①
UH-1-91-ASAM-03
improved particle
separator

SUBJECT - AVIATION SAFETY ACTION MESSAGE, INFORMATIONAL. RCS
CSGLD-1860(R1), ALL UH-1H/V HELICOPTERS, ADVANCE NOTICE OF MANUAL
CHANGES CONCERNING THE IMPROVED INLET PARTICLE SEPARATOR (IPS),
(UH-1-91-ASAM-03)

SUBJECT: Procedure for Transmission Cowl Interference

1730-EG-179-1
COVER CENTER

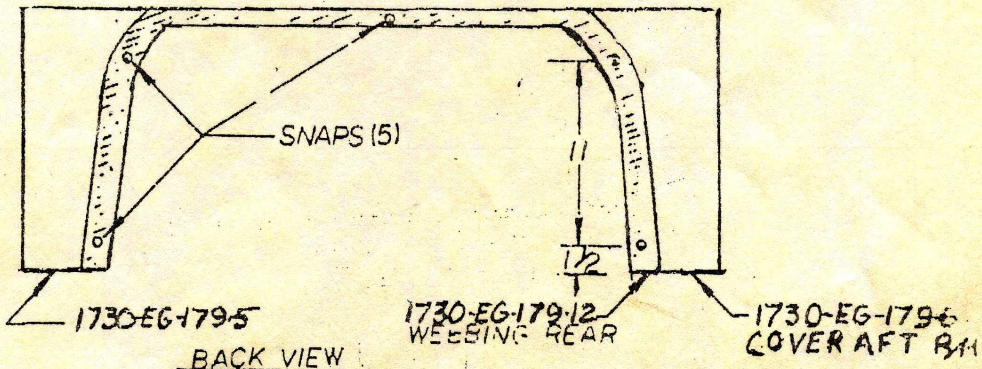
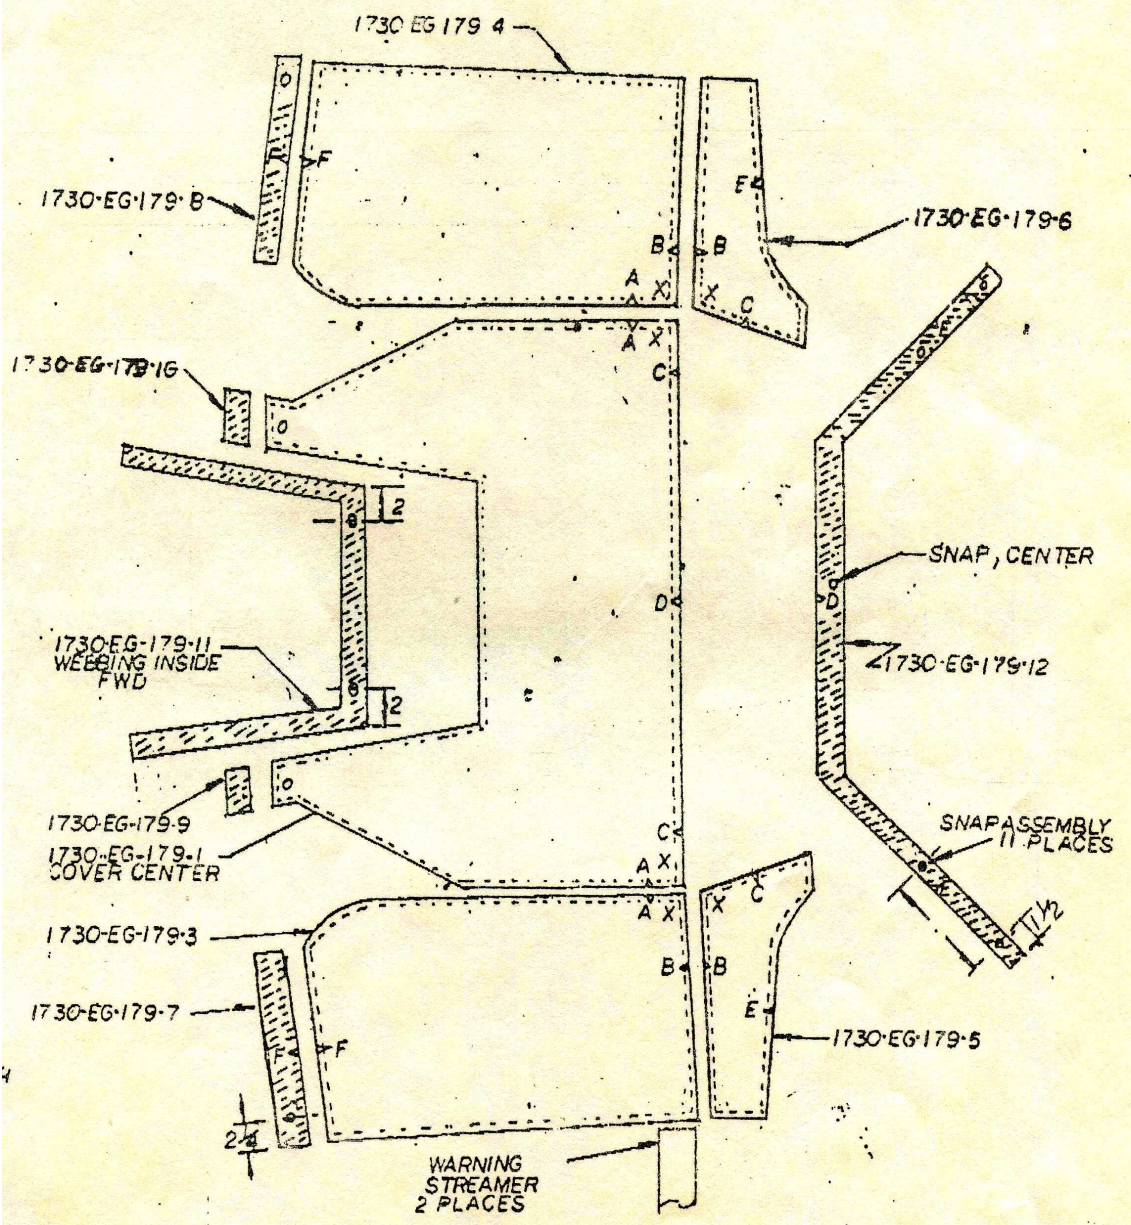
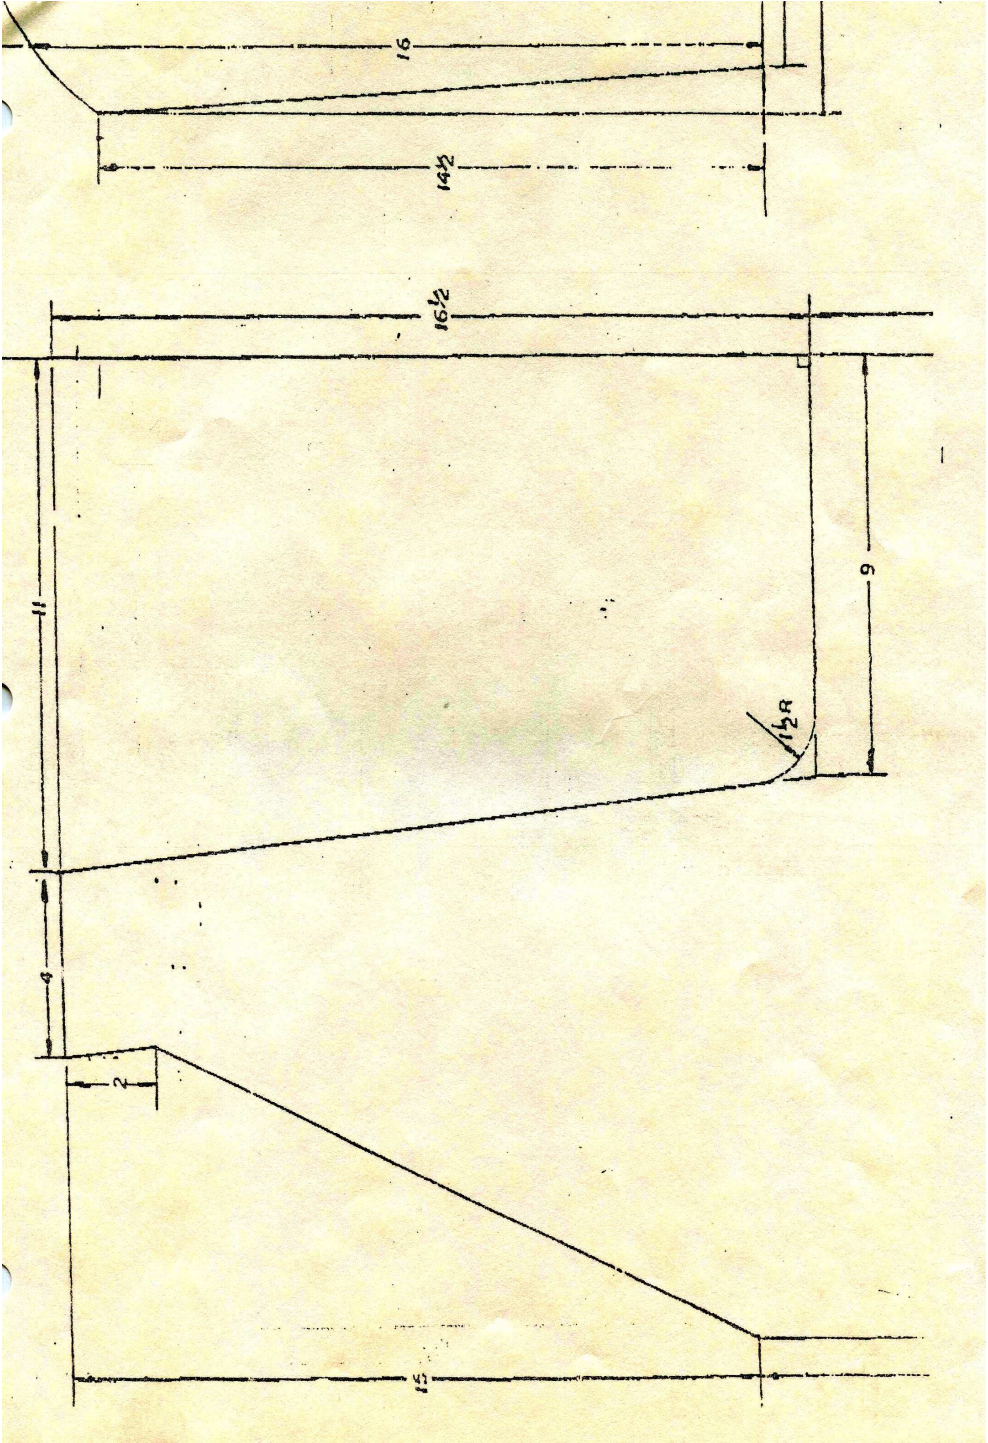
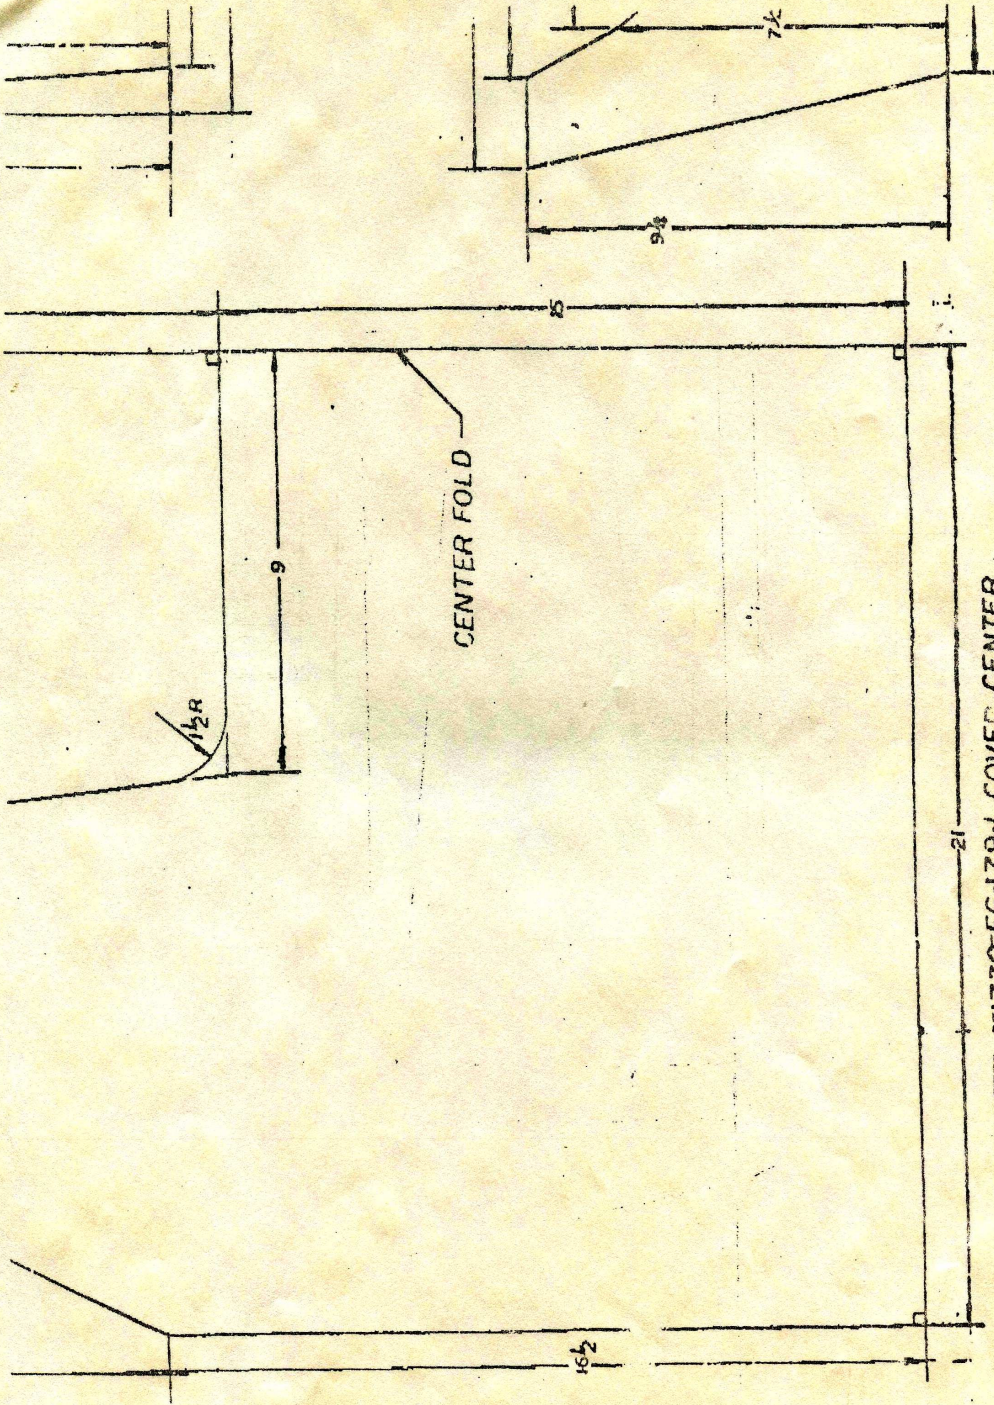
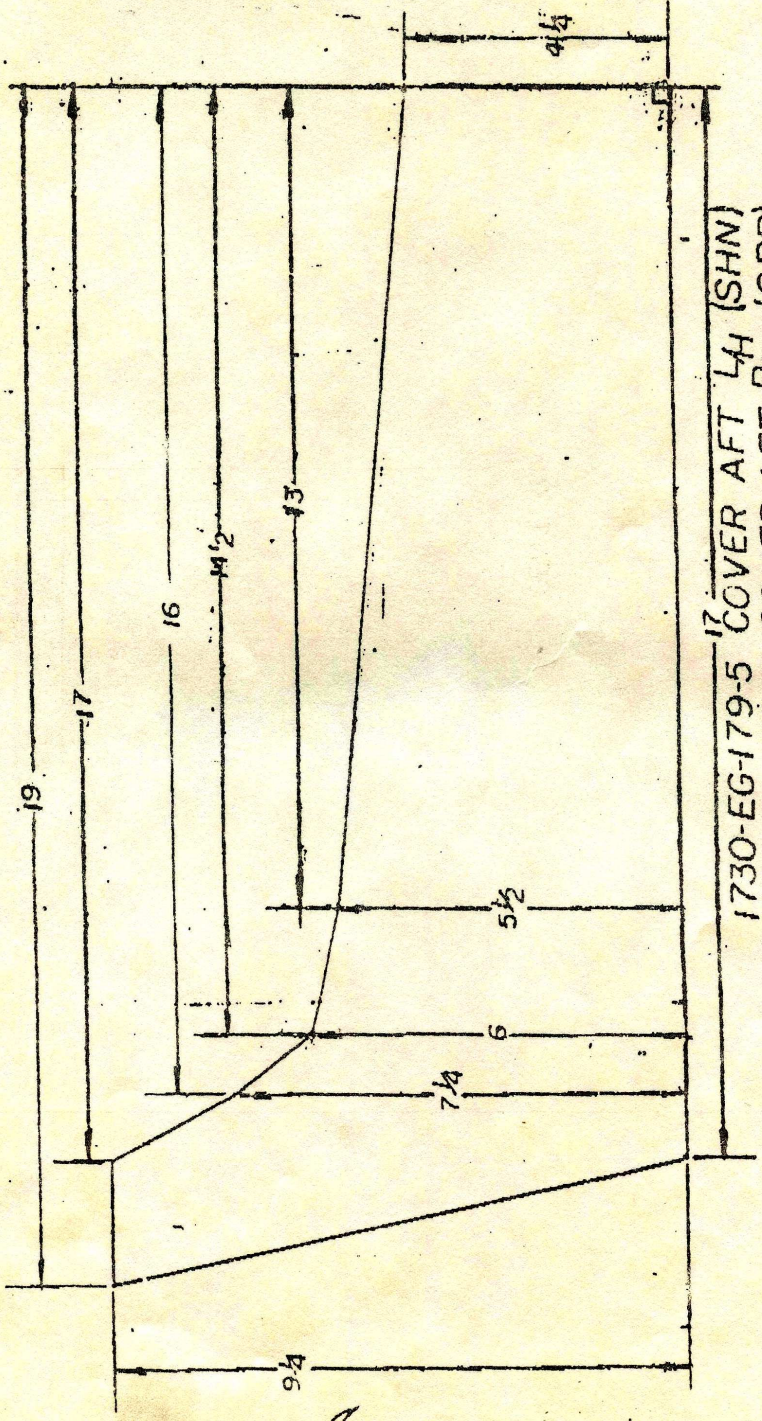
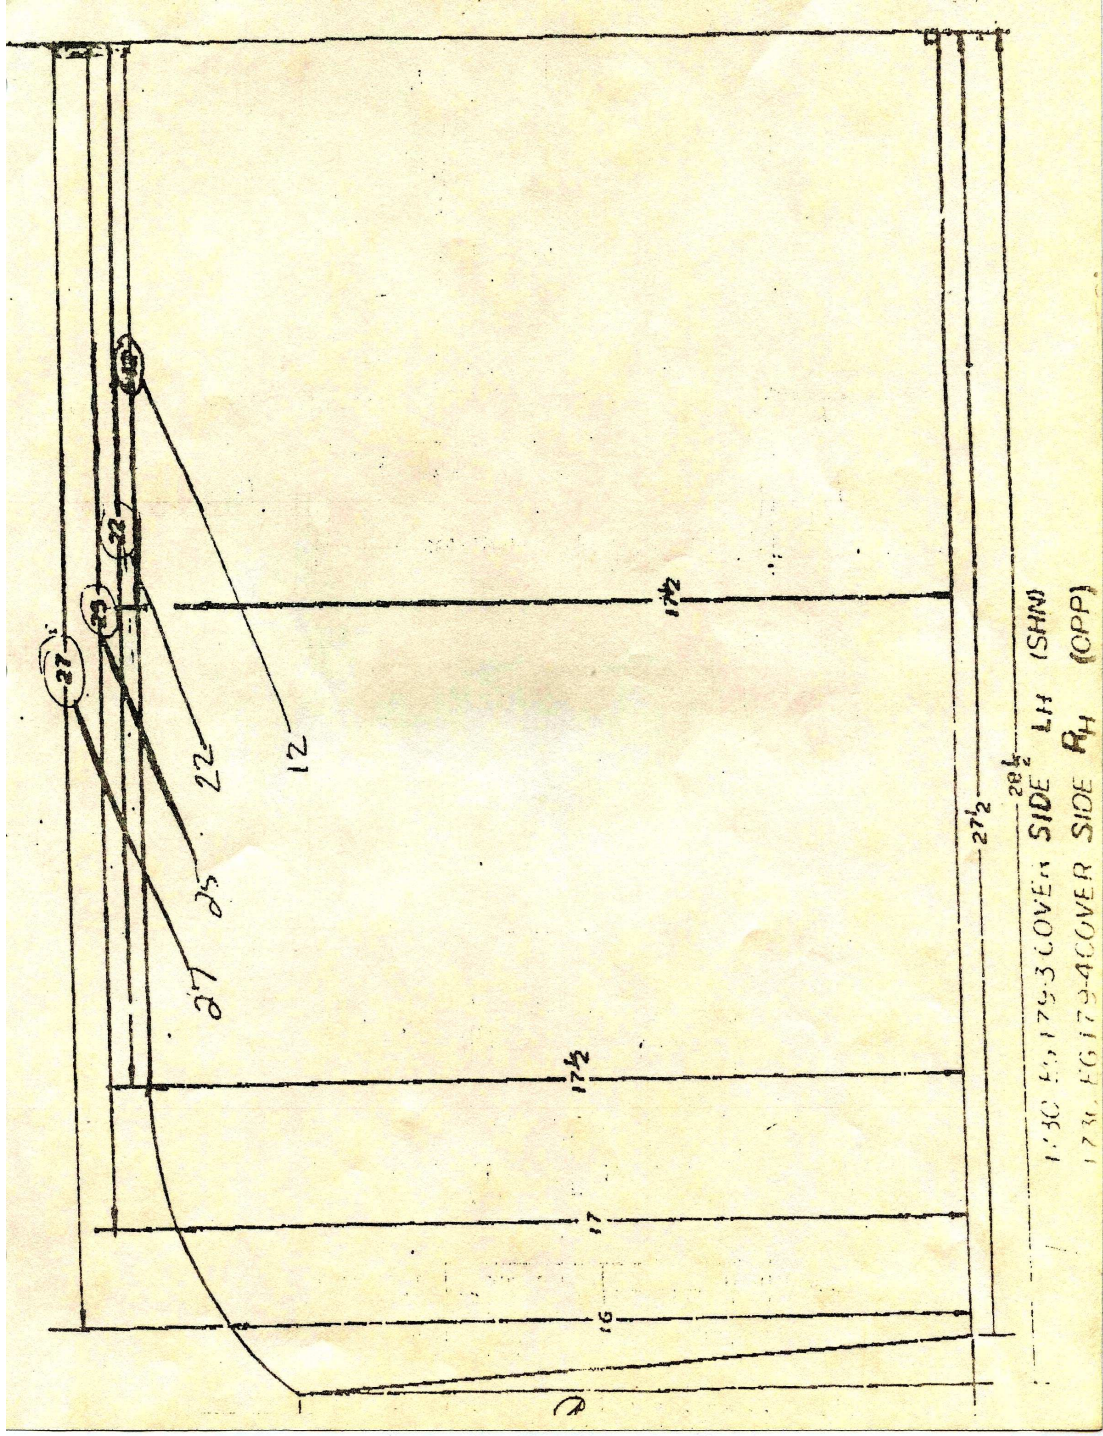
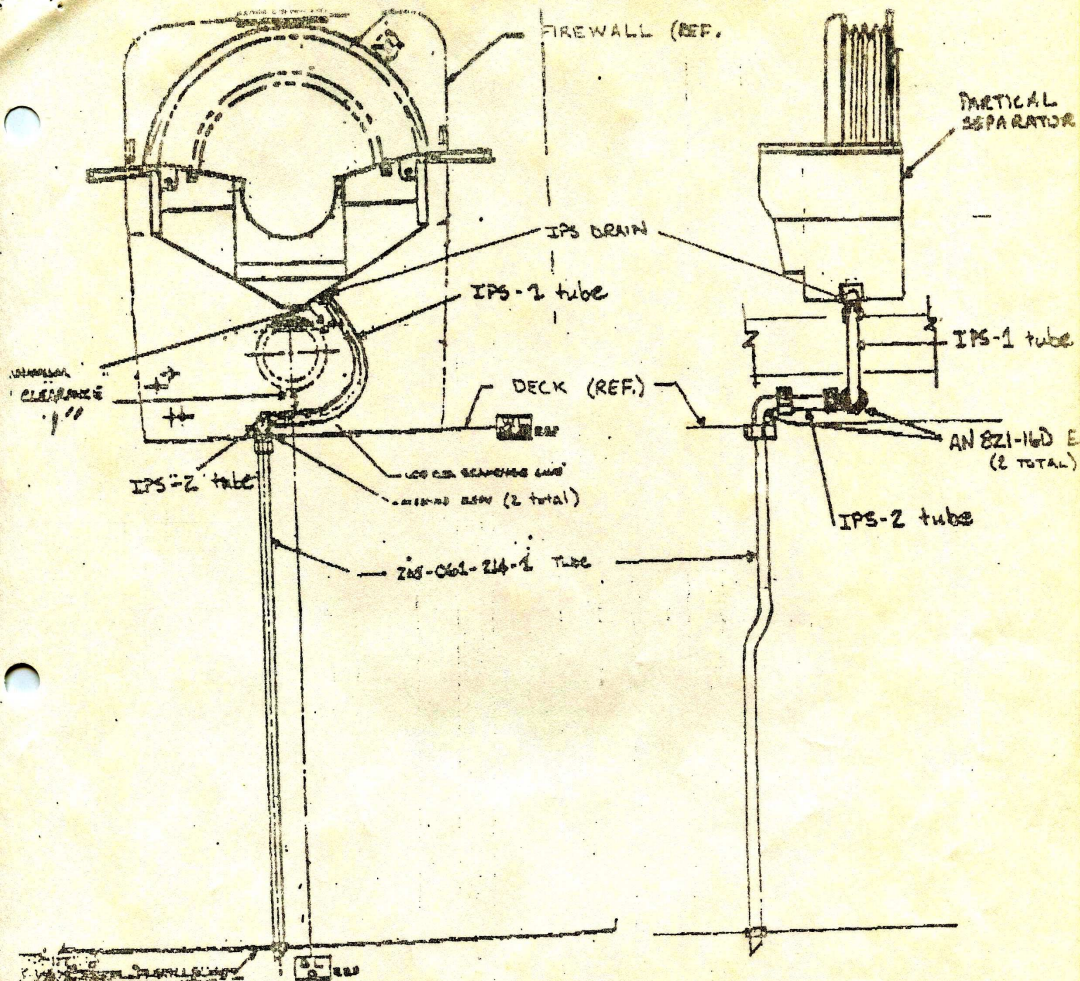
A. IPS COVER - AVIATION SAFETY MESSAGE, UH-1-90-ASM-02, IDENTIFIED A PROBLEM INVOLVING THE UH-1 IMPROVED PARTICLE SEPARATOR (IPS) AND ICE/SNOW ACCUMULATION IN PARKED AIRCRAFT. THE ASM RECOMMENDED COVERING THE IPS IN AREAS THAT WERE SUBJECT TO SLEET, FREEZING RAIN, OR SNOW. CONDITIONS IN SAUDI ARABIA HAVE SHOWN THAT BLOWING DUST AND SAND CAN ALSO ACCUMULATE IN THE ENGINE INLET AREA WHILE AIRCRAFT ARE PARKED. A COVER, P/N 1730FG179, HAS BEEN DEVELOPED FOR THE IPS THAT PROVIDES PROTECTION FROM ALL THE ELEMENTS MENTIONED. THIS COVER, P/N 1730FG179, IS A FIELD MAKE ITEM. ALL AIRCRAFT EQUIPPED WITH THE IPS SHOULD HAVE THIS COVER AVAILABLE FOR USE. TO OBTAIN A COPY OF THE DRAWINGS TO MAKE THE IPS COVER, P/N 1730FG179, CONTACT YOUR AVSCOM LAR.

DEVELOPED FOR THE IPS THAT PROVIDES PROTECTION FROM ALL THE ELEMENTS
MENTIONED. THIS COVER, P/N 1730FG179, IS A FIELD MAKE ITEM. ALL
AIRCRAFT EQUIPPED WITH THE IPS SHOULD HAVE THIS COVER AVAILABLE FOR
USE. TO OBTAIN A COPY OF THE DRAWINGS TO MAKE THE IPS COVER, P/N
1730FG179, CONTACT YOUR AVSCOM LAR.
